HISTORIC AND DESIGN REVIEW COMMISSION

August 18, 2021

HDRC CASE NO: 2021-362
ADDRESS: 412 MUNCEY
LEGAL DESCRIPTION: NCB 1655 BLK C LOT N 50.19 FT OF 19 & N 58.63 FT OF 20
ZONING: R-5, H
CITY COUNCIL DIST.: 2
DISTRICT: Dignowity Hill Historic District
APPLICANT: Angela Weber/AAV Handyman Services
OWNER: KANSAP ENTERPRISES LLC
TYPE OF WORK: Construction of a rear addition, door replacement, exterior modifications
APPLICATION RECEIVED: July 19, 2021
60-DAY REVIEW: Not applicable due to City Council Emergency Orders
CASE MANAGER: Edward Hall

FLOOR PLAN
PROPOSED

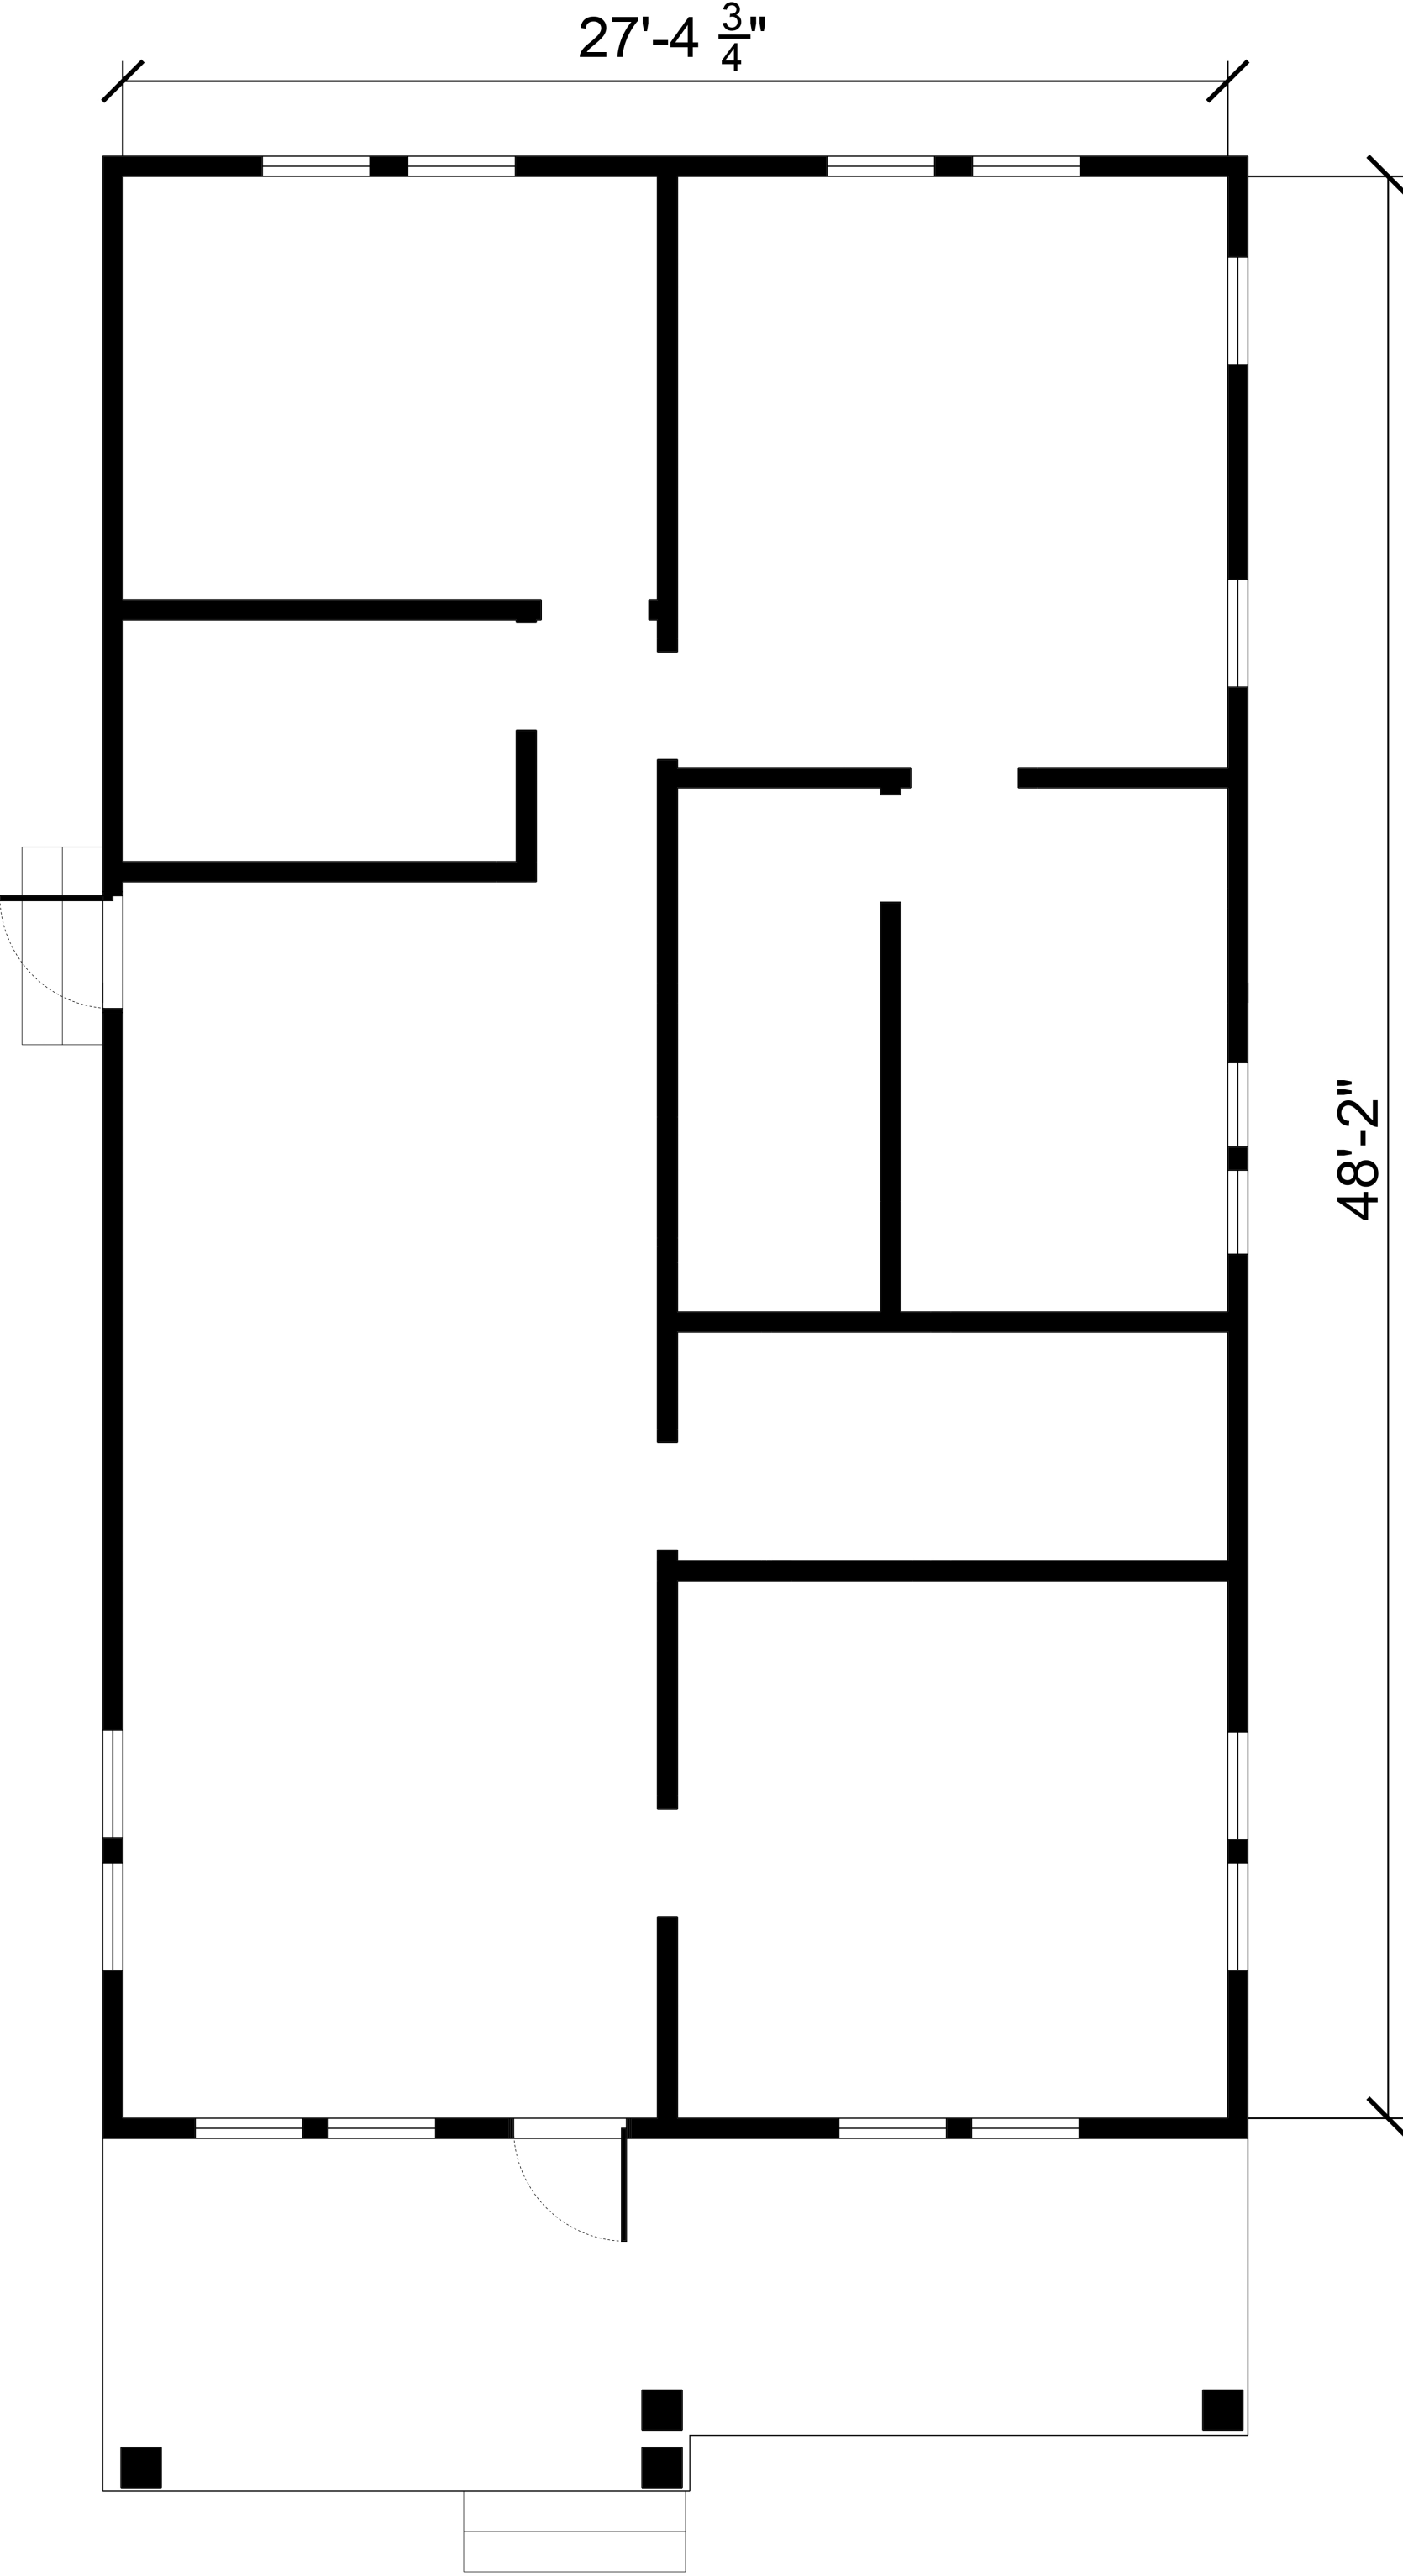
- b. REAR ADDITION – The applicant has proposed to construct a rear addition to feature approximately 550 square feet. The Guidelines for Additions 1.A. notes that additions should be sited to minimize view from the public right of way, should be designed to be in keeping with the existing, historic context of the block, should feature similar roof forms, and should feature a transition to differentiate the new addition from the historic structure. Additionally, the Guidelines for Additions 1.B notes that additions should be subordinate to the principal façade of the historic structure, should feature a footprint that responds to the size of the lot, and should feature an overall height that is generally consistent with that of the historic structure.

NORTH ELEVATION

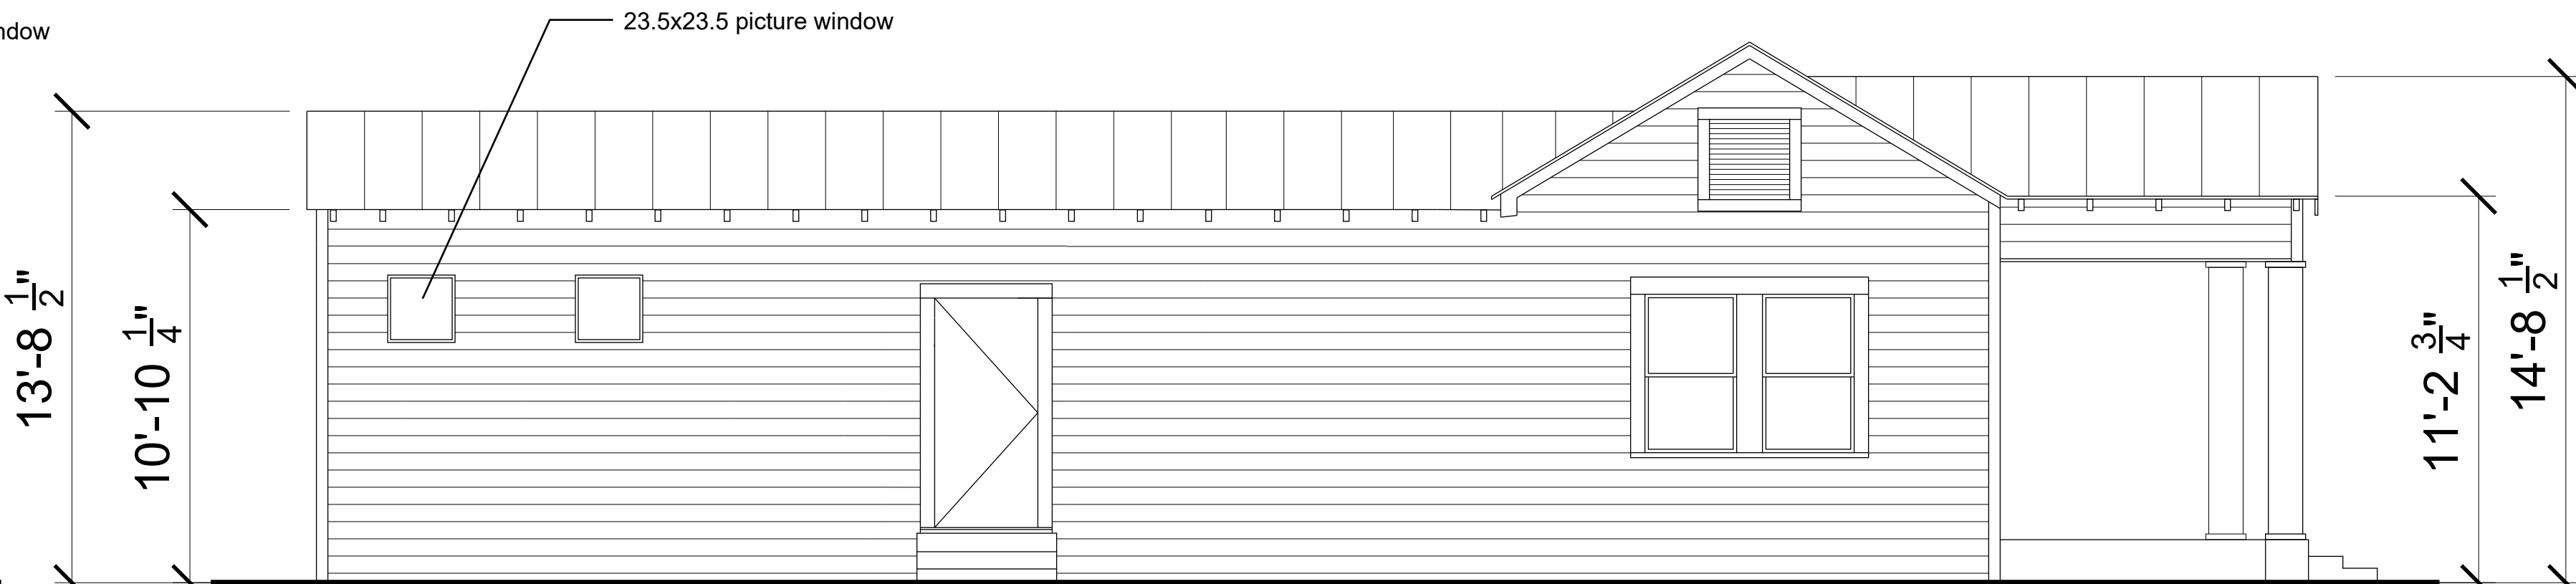
- c. REAR ADDITION (Architectural Details) – The applicant has proposed facades that are generally consistent with the Guidelines for Additions; however, staff finds that the small picture windows proposed on the left elevation are inconsistent with the Guidelines. Staff finds that windows that are sized consistently with those found historically within the district should be incorporated into the design. Additionally, staff finds that an additional window opening should be added between the door and grouped windows on the north façade.

1. Staff recommends approval of item #1, the construction of a rear addition based on findings a through d with the following stipulation:
 - i. That the two square windows on the north elevation be eliminated and that windows that are sized consistently with those found historically within the district should be incorporated into the design.

- ii. That an additional window opening be added between the door and grouped windows on the north façade.
 - iii. That the proposed standing seam metal roof feature panels that are 18 to 21 inches wide, seams that are 1 to 2 inches in height, a crimped ridge seam and a standard galvalume finish. A ridge cap is not to be installed.
